OFFICE OF CLIMATE, LICENSING & RESOURCE USE

TO: DIRECTORS FROM: Brian Meaney - Licensing Unit DATE: 29 September 2010 Application for a waste licence review from CAVAN COUNTY COUNCIL in relation to the Corranure Landfill, Licence Register number W0077-04

Figure 2 Current ownership and licensed area vs licence review (in red)

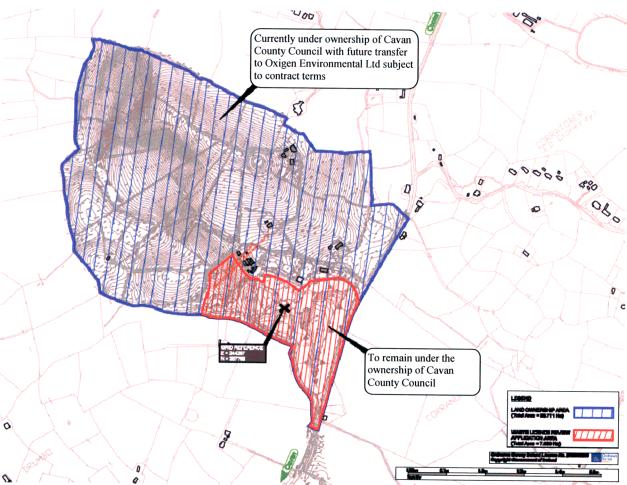
to Oxigen Environmental Ltd. The agreement includes sharing of leachate and landfill gas infrastructure by both parties with the landfill gas flare units and the leachate storage tank and lagoon remaining in their existing locations on lands to be sold to Oxigen Environmental Ltd. Figure 2 shows the reduction in area proposed by Cavan County Council.

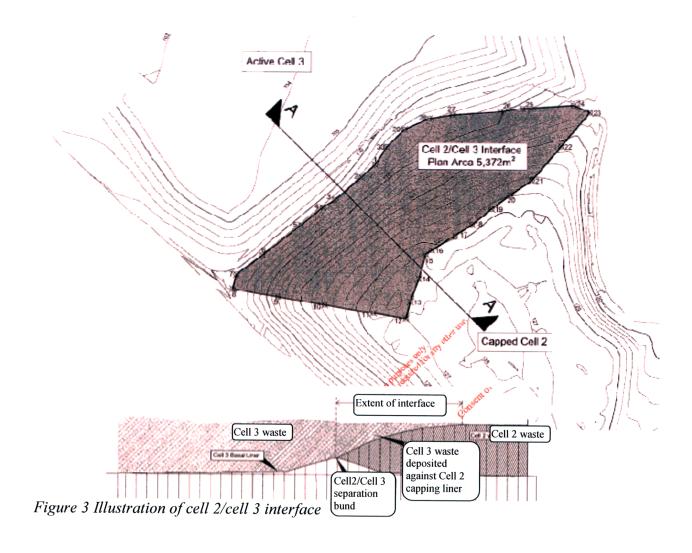
Both parties have entered into a separate legal contractual agreement whereby both parties agree to offer the EPA joint and several liability in respect of any environmental issue relation to the cell 2/cell 3 interface area. The interface area is illustrated in Figure 3.

The boundary between Cavan County Council's and Oxigen's respective facilities is nominally between cells 2 and 3. However, there is no vertical plane separating these two cells. As illustrated in Figure 3, cell 3 was constructed on top of the sloped flank of cell 2. The facility boundary is therefore 3-dimensional and any environmental pollution incidents traced back to this area will require the co-operative approach of each party to determine liability. This is provided for by condition 1.9 of the RD.
